Technical Bulletin

Bulletin Number: 239 Revision Number: R-01
 Release Date: September 9, 1981 Revision Date: July 30, 1992

SUBJECT: OSCILLATOR

MODEL: DNCB 630/360-5 Select and 6 Select

View Of Oscillator
 (For Reference Only)

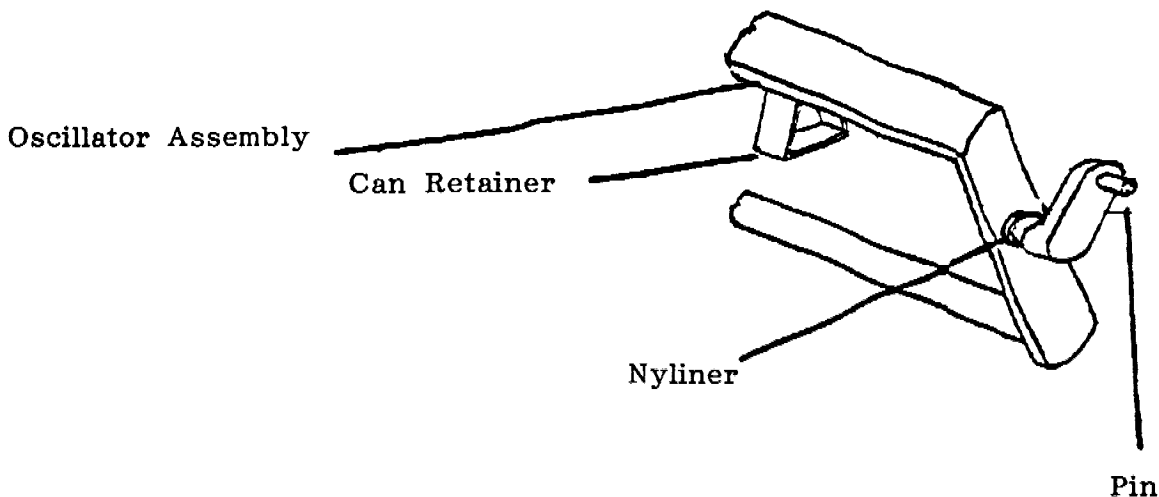
REASON: To increase the diameter of the pin on the oscillator increasing its strength.

**BEGINNING SERIAL NUMBER: 0001-2470CF and up have the new oscillator factory installed.
 (Approximate Date: 09/18/81)**

Other parts will change at the same time, therefore a kit will be necessary when ordering replacement oscillators for venders serialized prior to 0001-2470CF.

<u>KIT WILL CONSIST OF:</u>	1	D801,200,990.41	Oscillator-3D
	1	A801,201,030.01	Linkage Arm
	1	801,804,770.01	Nyliner (small) For Linkage Arm
	2	901,700,650.31	Can Retainer
	1	801,803,170.01	Nyliner (large) For Oscillator
